Name Capital Career Center - Bid Package 2
Owner SCC

ADDENDUM

Number 1

ADDENDUM #1 – PART 1
Bid Package 2

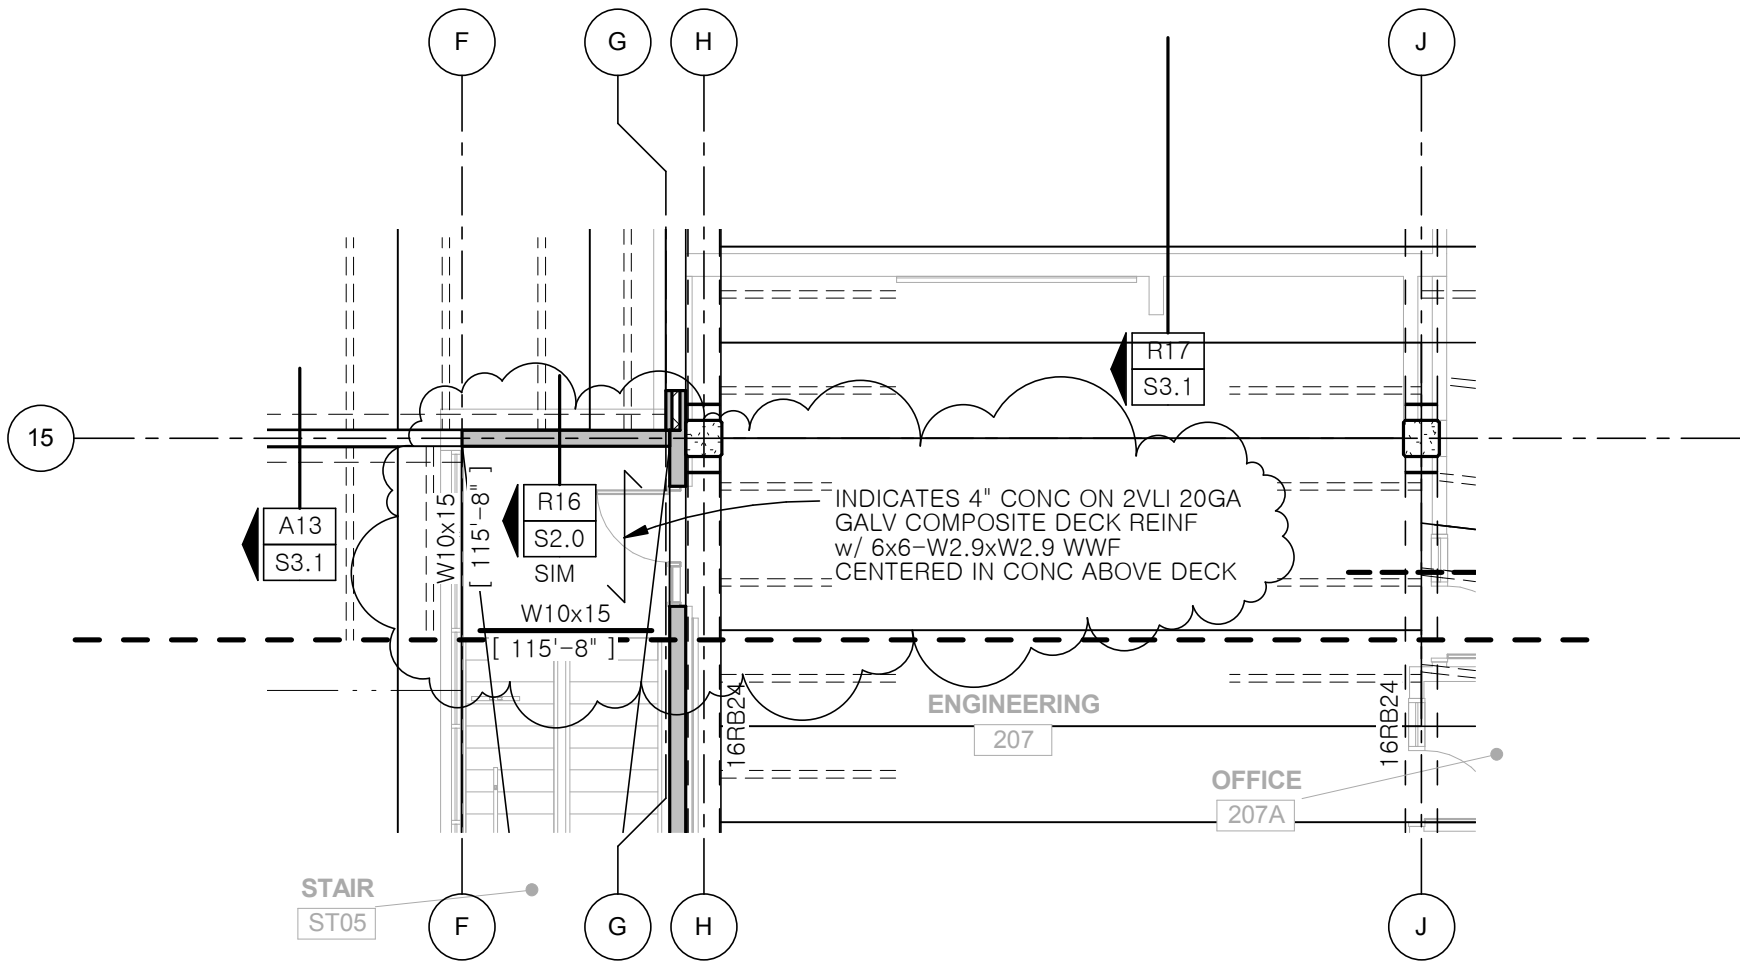
1. Provide a credit to combine all three concrete contracts into one contract. Fill in 'No Bid' if not bidding all three base contracts. Contracts may be awarded separately.
- E. Alternative No. 5: The Contractor shall state the amount to deduct from the Base Bid to perform the following changes:
1. Provide a credit to remove the Southeast portion of the drive as detailed on supplemental drawing.

PARTIAL AREA C FOUNDATION PLAN

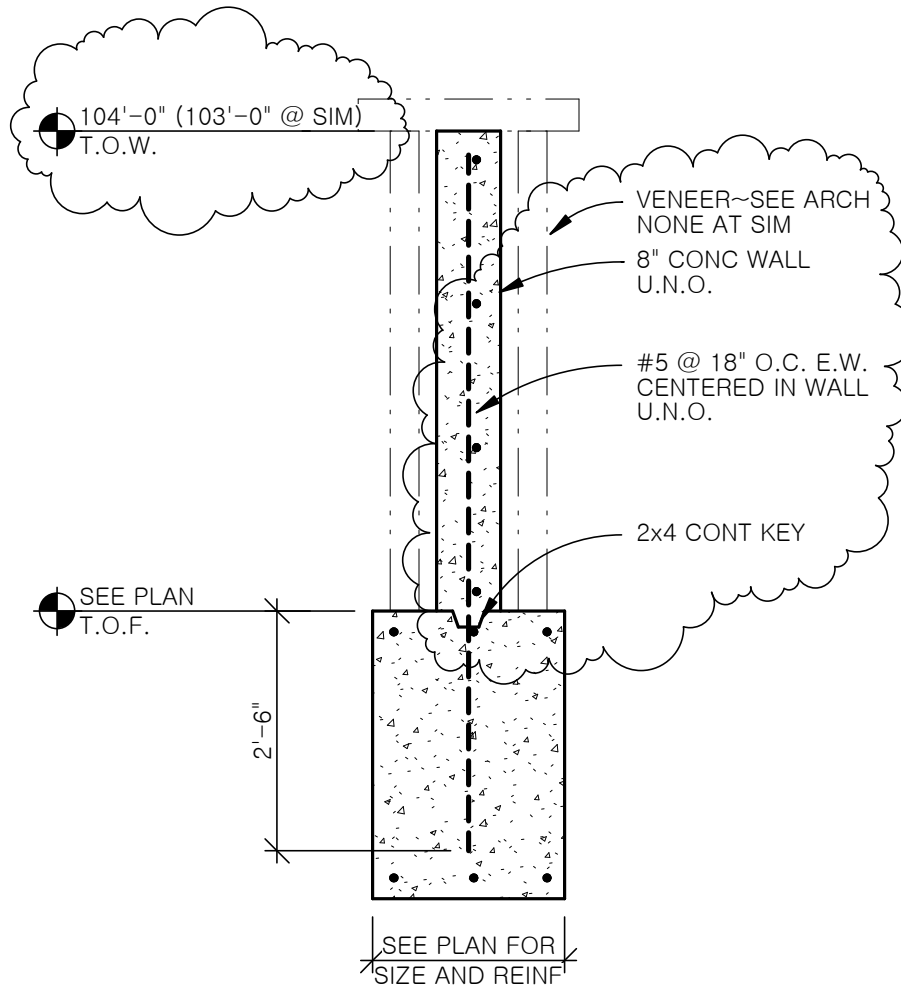
1. HSS 4x4x1/4, w/ 5'-6"x2'-6" FTG w/ 6-#4x5'-0" LONG & 8-#4x2'-0" TRANS BOT [TOF = 107'-4"]
~SEE DTL FOR DEPTH
2. 12" CONC SITE WALL REINF w/ #5 @ 12" O.C. E.W. CENTERED IN WALL
~APPROXIMATE LENGTH IS 120'-0" SEE CIVIL FOR EXTENTS
